**CITY OF GAINESVILLE PLANNING DIVISION
SUMMARY OF COMMENTS**

Petition Number: 167SUB-00 DB	Reviewed by: Gene G. Francis
Development Review Board Meeting: December 14, 2000	
Project Name/Description: East Side Oaks Subdivision

Petition No. <u>167SUB-00DB</u>	Date Plan Rec'd: <u>12/05/00</u>	Review Type: <u>Design Plat</u>
Review For: <u>Development Review Board</u>	Review Date: <u>12/14/00</u>	Project Agent:
Description, Agent & Location: <u>East Side Oaks Subdivision</u>		<u>Eng, Denman & Assoc.</u>

DESIGN PLAT
 -NOT FOR FINAL RECORD
 NEW GAINESVILLE, A REPLAT
 TO BE KNOWN AS "EAST SIDE OAKS"

EAST SIDE SUBDIVISION GAINESVILLE,

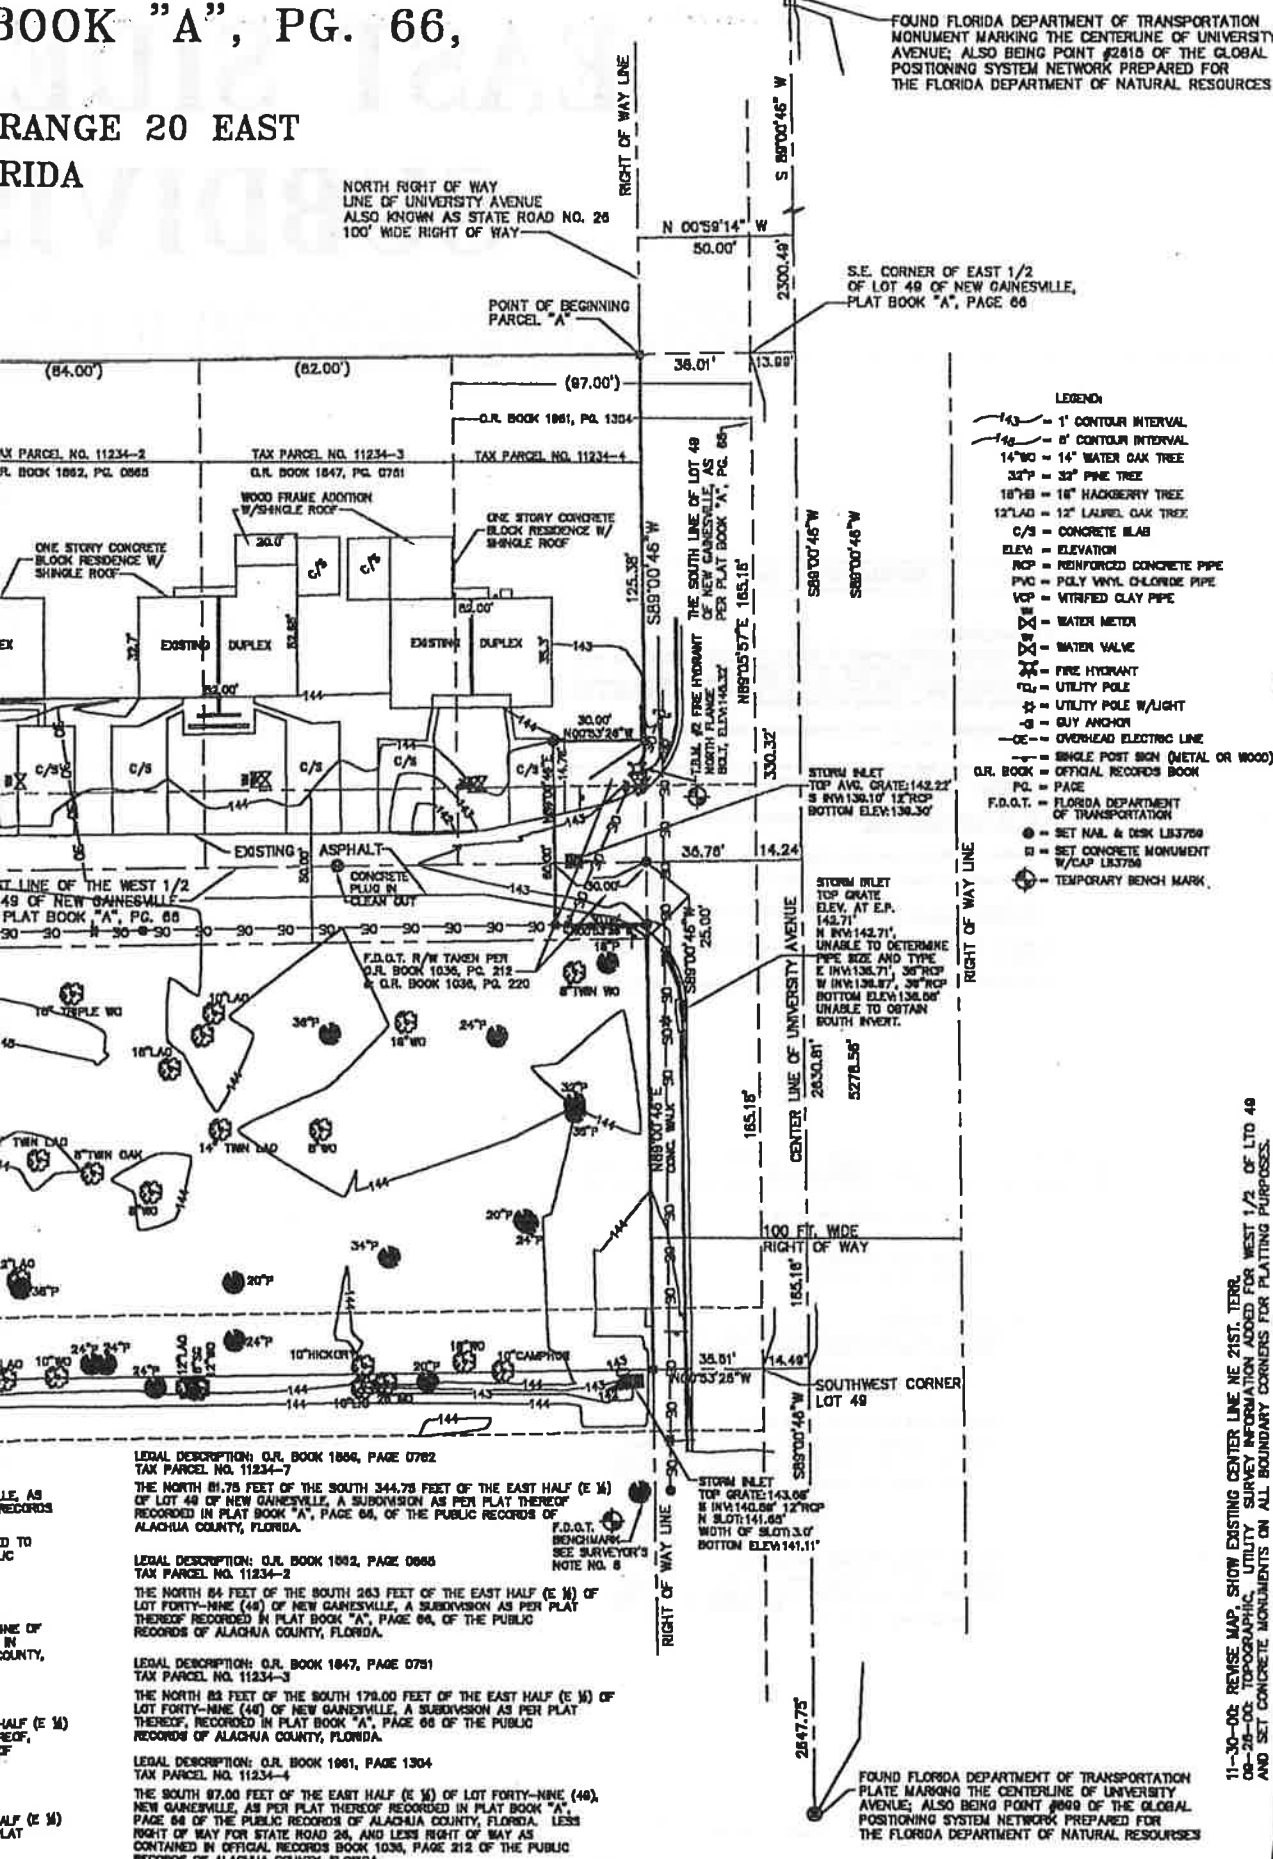
1. Planning staff would like for the petitioner to locate their new streetside sidewalks away from the edge of the street itself, if possible, shifting it to the outer limits of the right-of-way. If the sidewalk can't be shifted on the east side of the street due to existing conditions, it should be done on the west side at least.
2. If possible, the petitioner should clearly indicate what the "Center Line" off-set is between the two NE 21st Streets.
3. It should be clearly understood (and noted) that the new lots should not be cleared until individual lots are ready to be developed.

4. Note # 4 on the Design Plat has several mistakes due primarily to changes made to the design plat since the initial submittal.
5. There should be a note on the design plat and final plat that there shall be no direct access to East University avenue from Lots # 1 & 18 and also no direct access from Lots # 7 & 8 to NE 3rd Avenue.
6. All reference to building setbacks must be excluded from the "Final Plat".
7. There are several small errors in Note # 1 on sheet 1 of 4 dealing with "Cluster Subdivision" and sidewalk on west side only, not both sides.
8. Please clarify the sidewalk and gate detail by shading the sidewalk.
9. Be sure that the construction plans include landscape plans for the water retention area along with street trees.

1. A vehicular connection will not be permitted onto NE 3rd Ave. due to the alignment with NE 21st Terrace north of NE 3rd Ave. The City of Gainesville Land Development Code requires that all driveways must align evenly or be offset a min. of 150 Ft.

Please show the trees to be planted on the Paving, Grading and Drainage sheet.

Required Trees must be planted. Nine trees (Bald Cypress, Southern Magnolia, River Birch, or Live Oak) in 30-gallon containers must be planted around the drainage retention basin. Either hose bibs within 100' of each tree or an automatic irrigation system must be specified to ensure they receive adequate water.

Shade trees from the Gainesville tree list must be planted on 50' centers on both sides of the right-of-way to provide street shade. They can be planted on or within 5' of the right-of-way and can either be installed at the time the infrastructure is completed or when the homes are built and as the Certificates of Occupancy are applied for. The selected alternative and agency responsible must be identified on the design plat.
